Agenda
Village of Glen Ellyn
Plan Commission Meeting
Thursday, May 4, 2023
7:00 PM
Glen Ellyn Civic Center, Galligan Board Room

STAFF REPORT

SUBJECT: 490 Kenilworth Avenue - Frank Johnson Center; Glen Ellyn Park District-Special Use Permit and Zoning Variation

REQUEST: Approval of a Special Use Permit associated with construction of a new maintenance facility, associated outdoor storage, and site development. In order to accommodate the project, the petitioner is specifically requesting approval of the following:

SHEET TITLE
Planting Plan

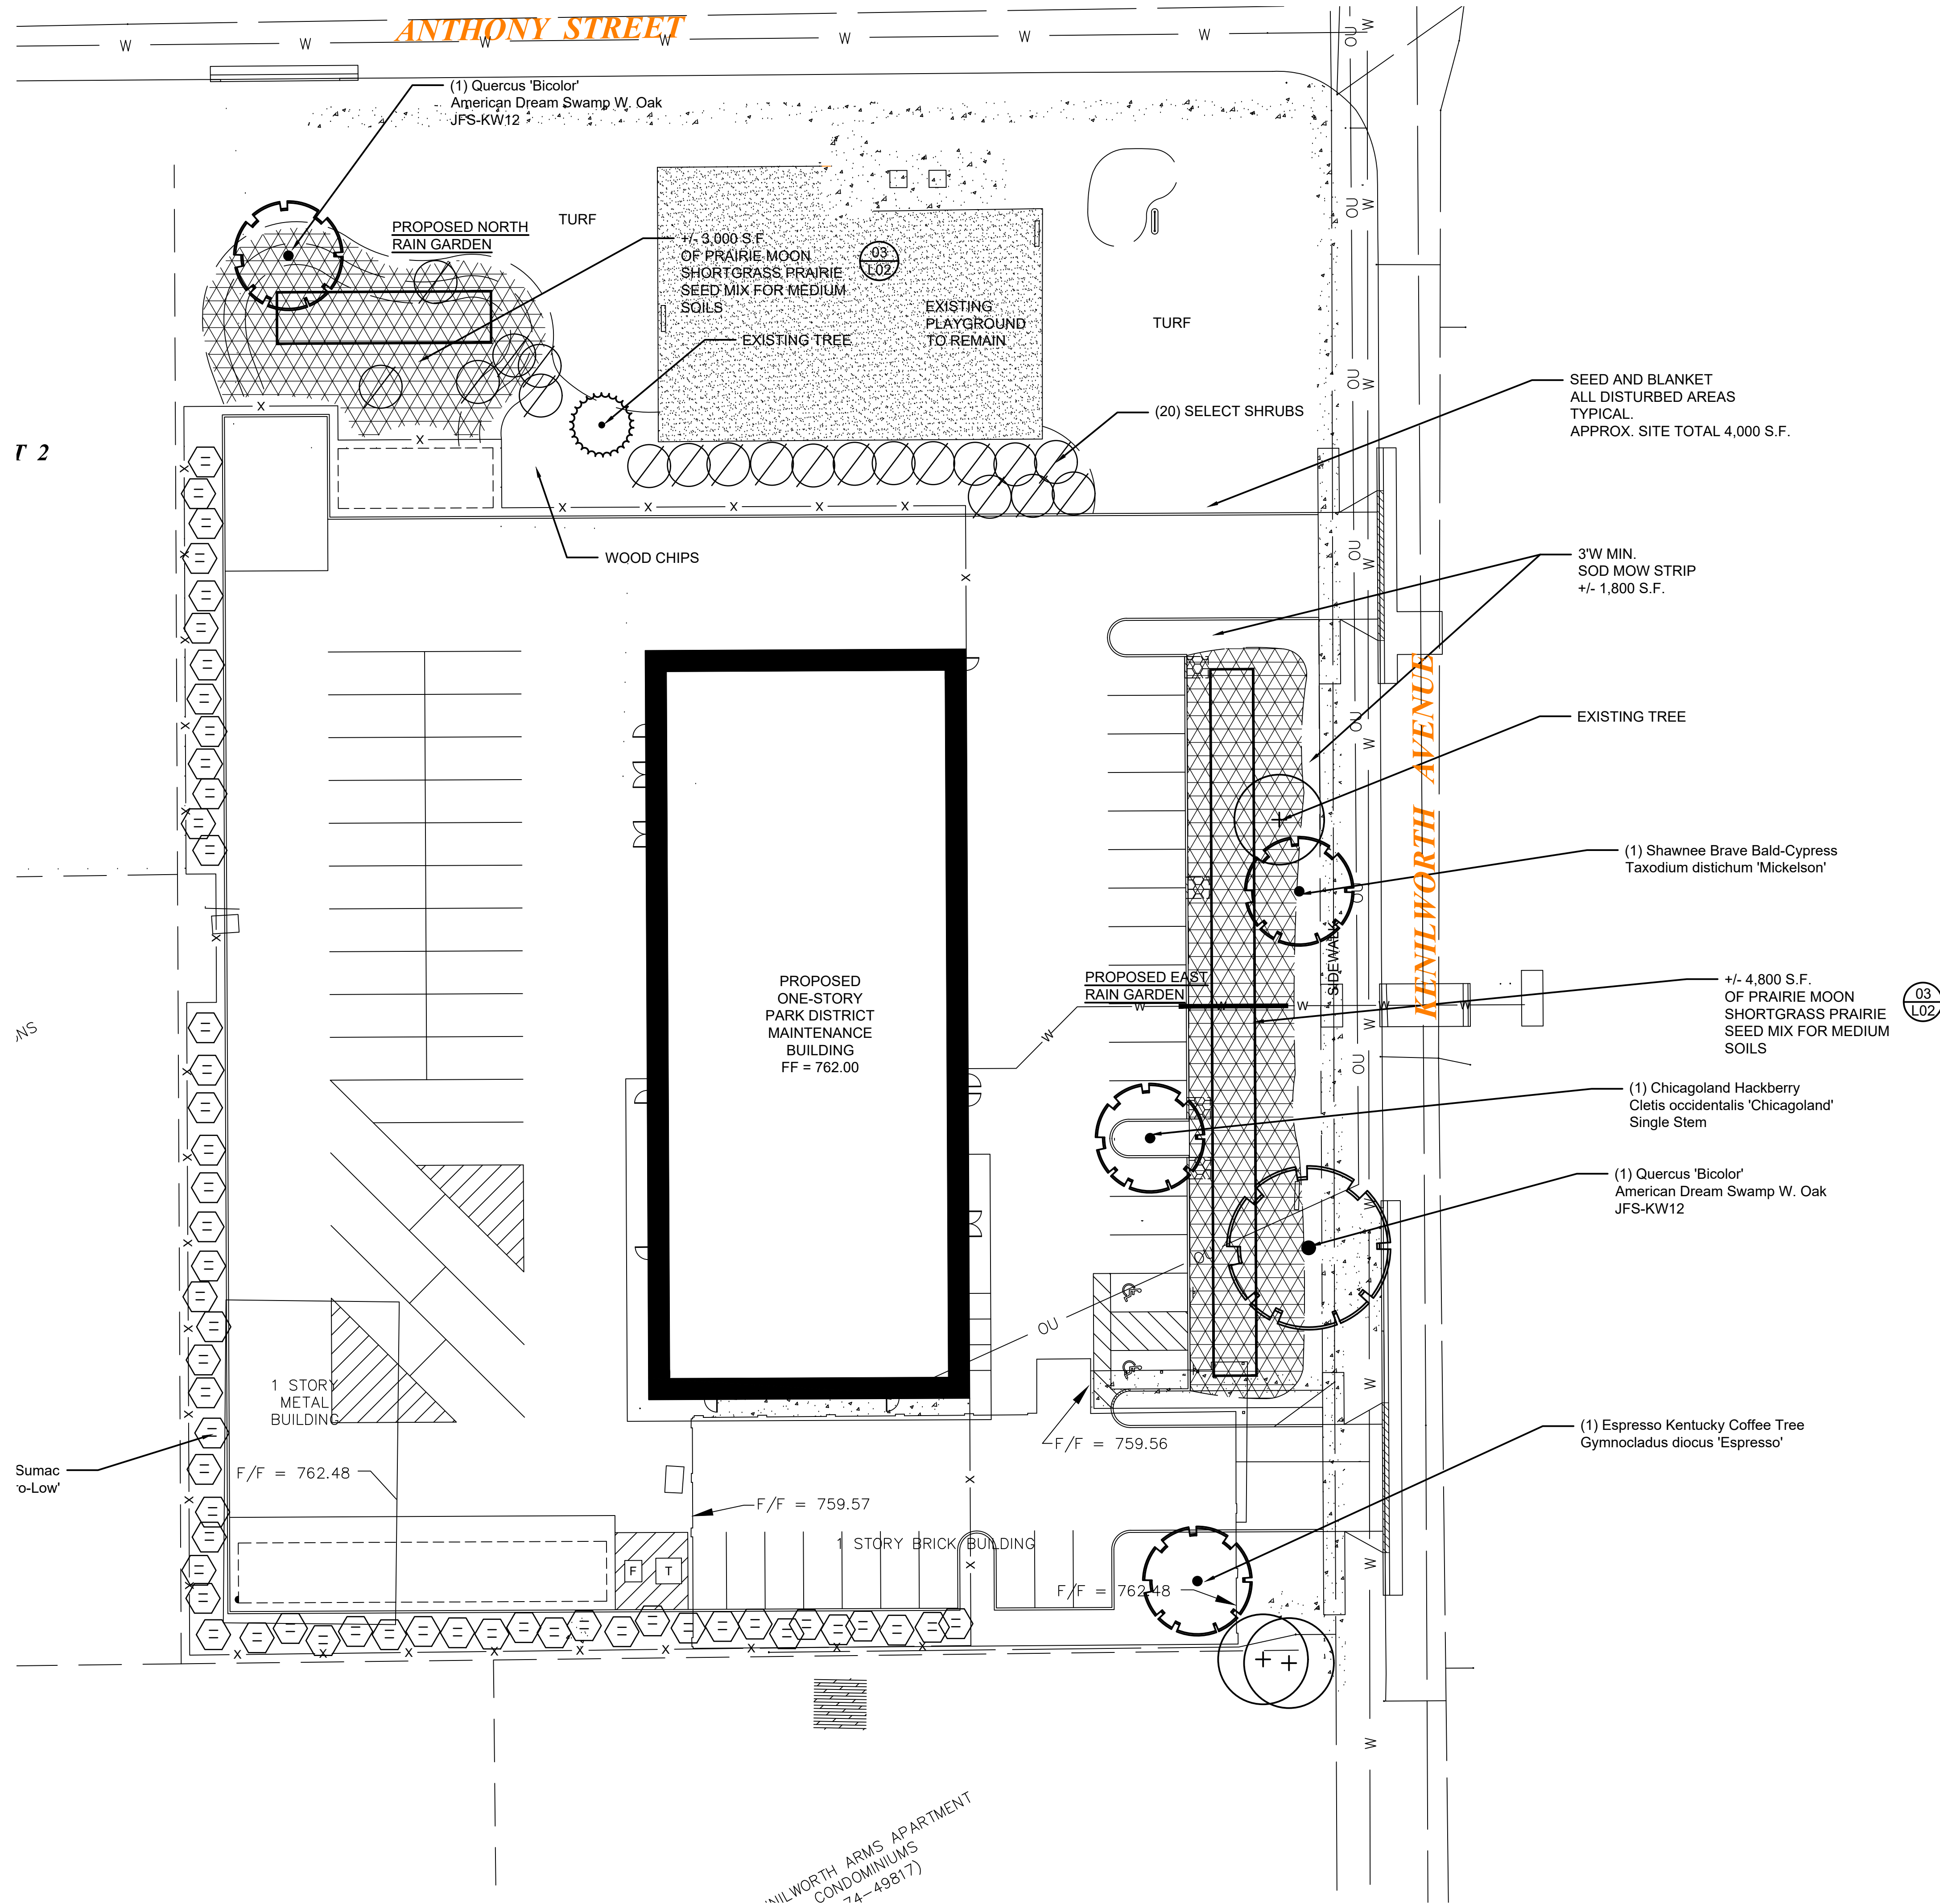
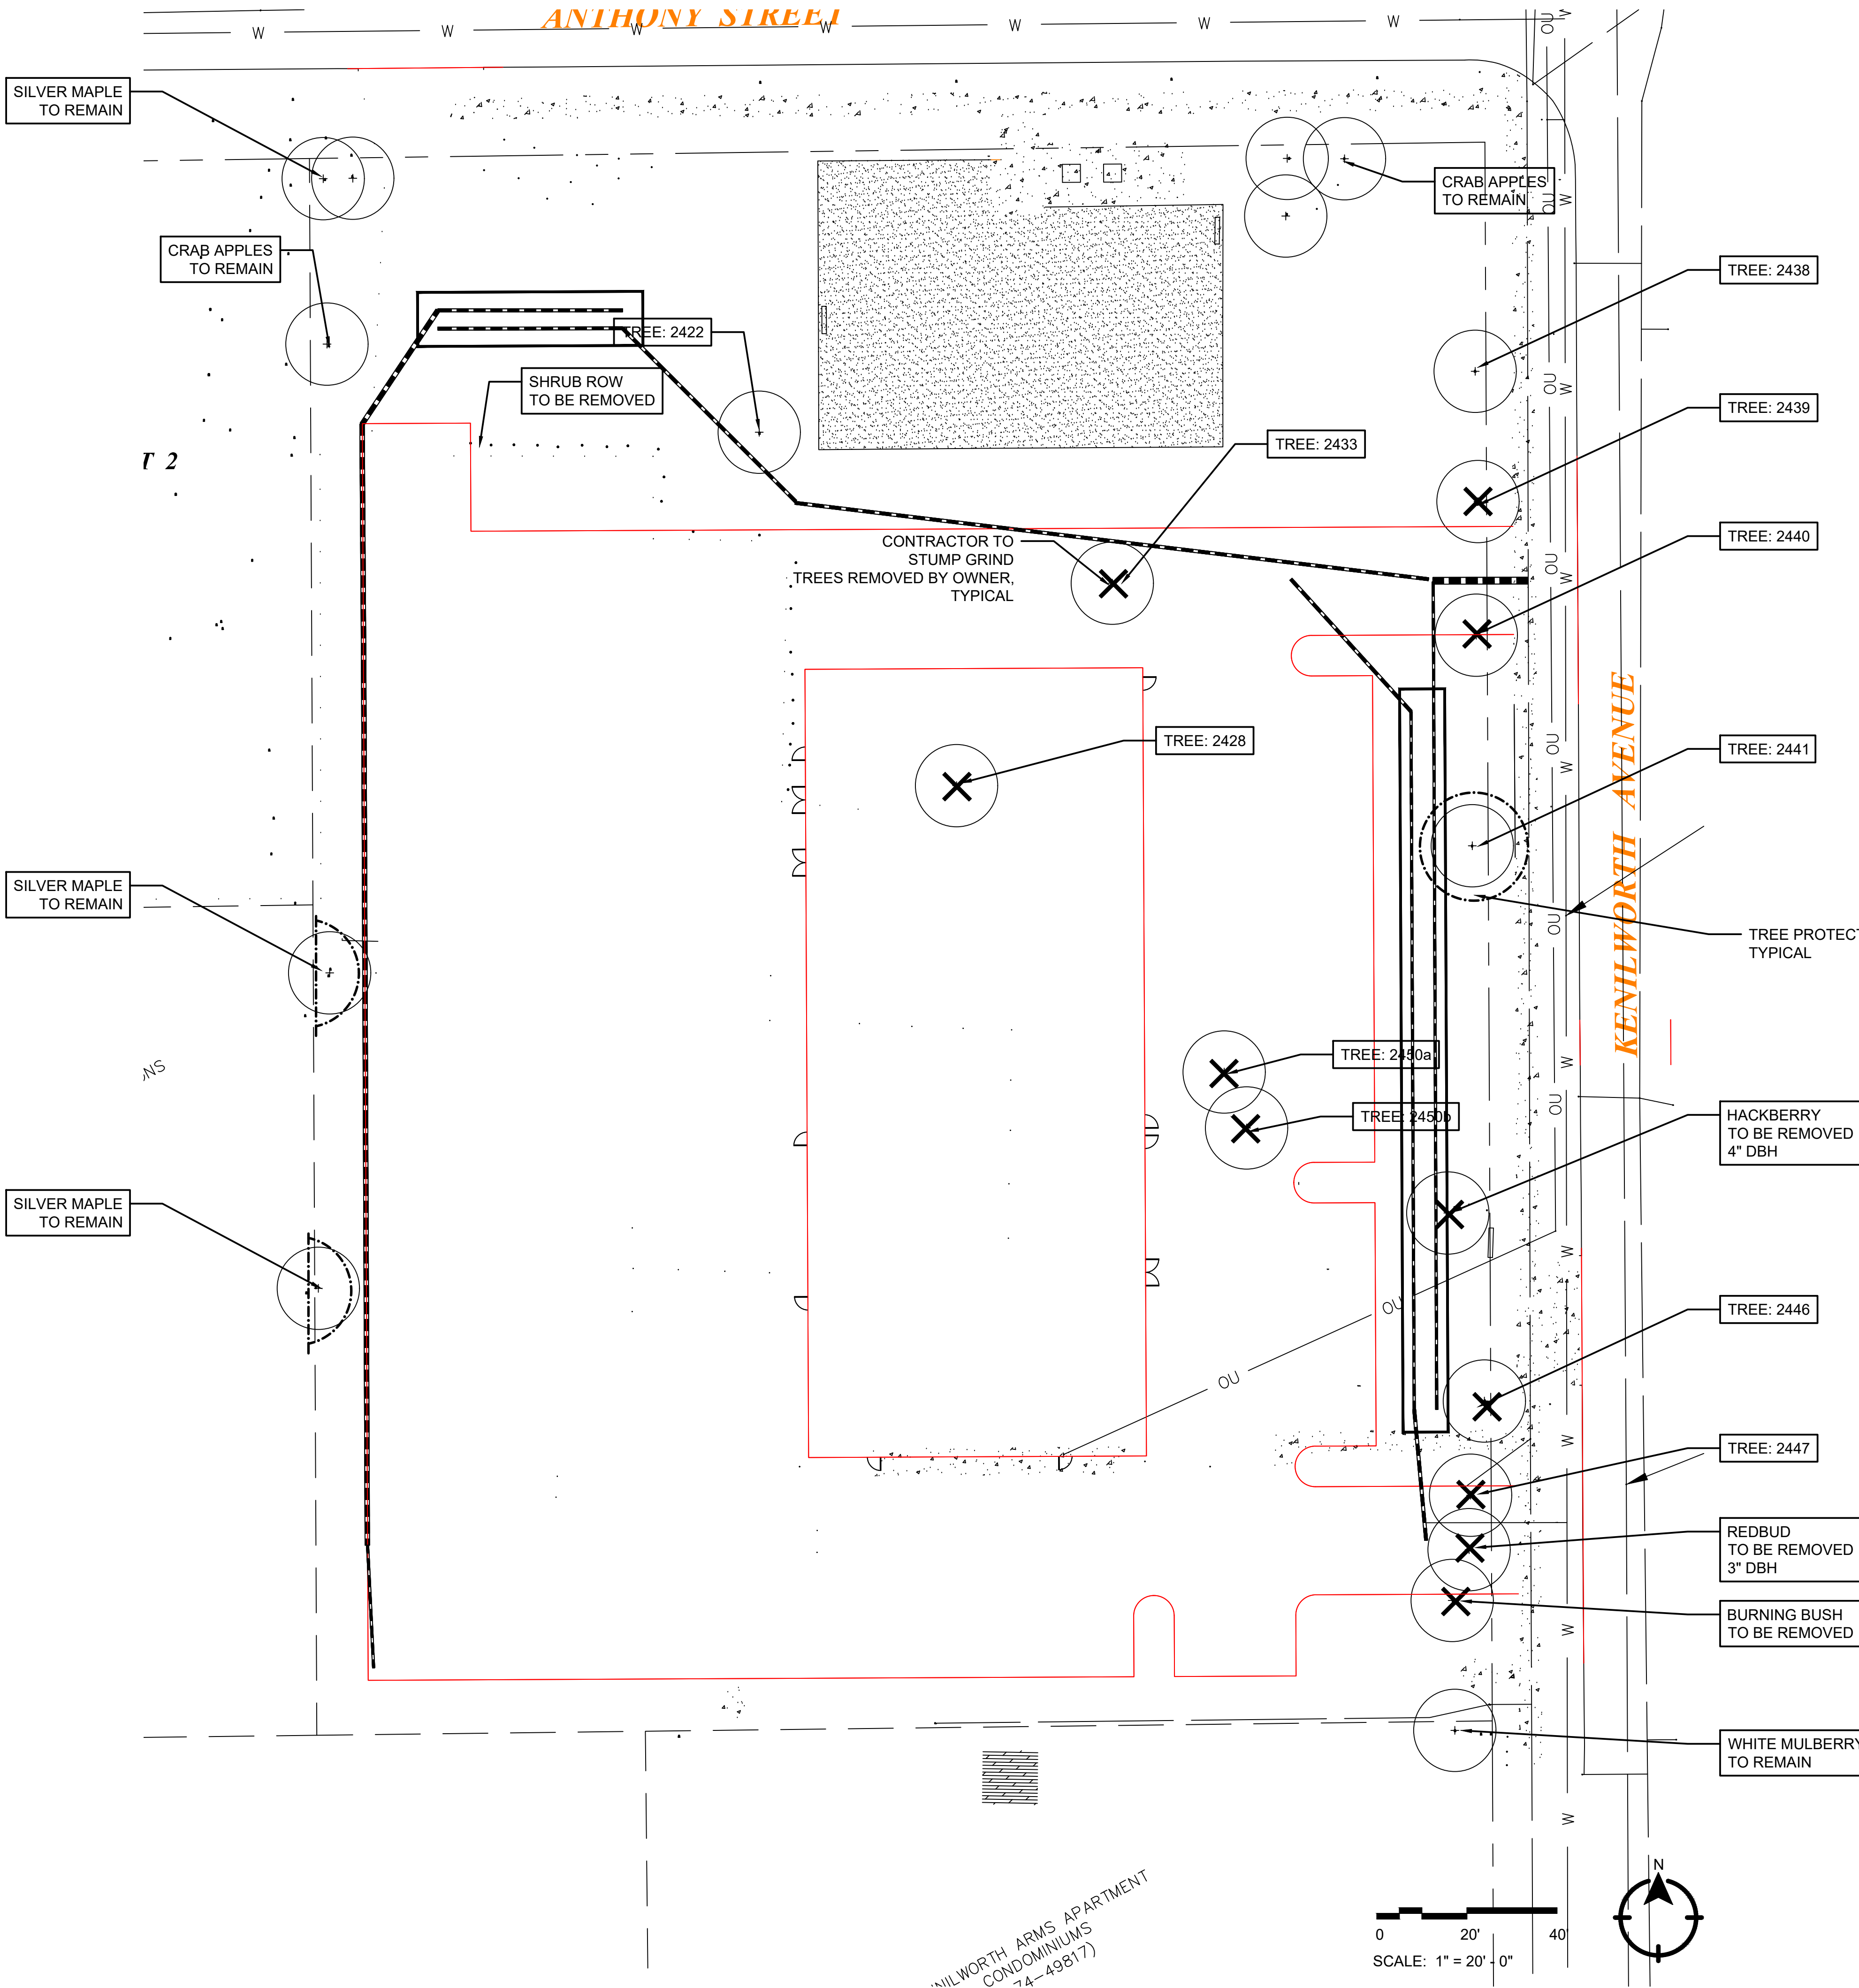
5. Landscaping. The Park District has presented a Landscape Plan which is satisfactory. The plan contains two rain gardens: the larger buffers the parking area from Kenilworth Avenue. The second raingarden is west of the existing playground. Municipal staff had suggested additional ornamental tree or two near the site's northeast corner. Petitioner has stated that the existing playground is due for a planned renovation and this comment will be addressed at that time.
